**Addendum
No. 4**

Date: March 28, 2018

Project: Caesar Rodney High School
Sitework and Athletic Fields
Contract N. SRS-18003-CRHSSitework

ELECTRICAL SITE PLAN - STORAGE BUILDING

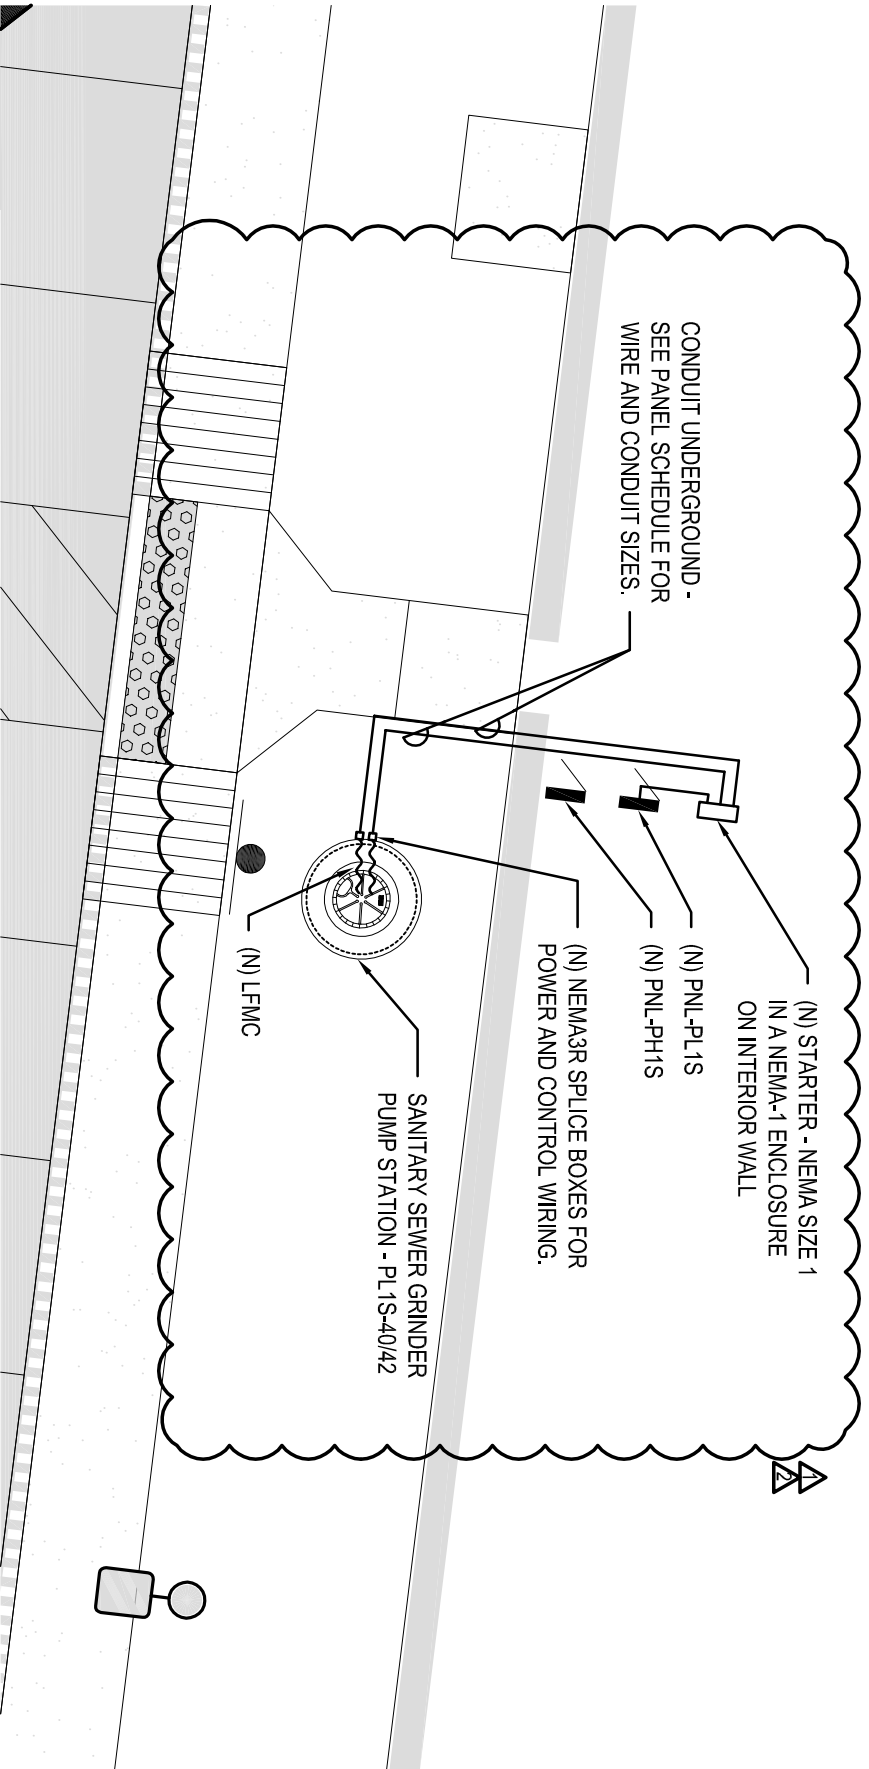
5. E9.3 – ELECTRICAL SITE PLAN – STORAGE BUILDING
Moved the starter for the grinder pump to the interior of the storage building on the wall next to the panelboards.
See attached sketch SK-E.01 Rev.1.
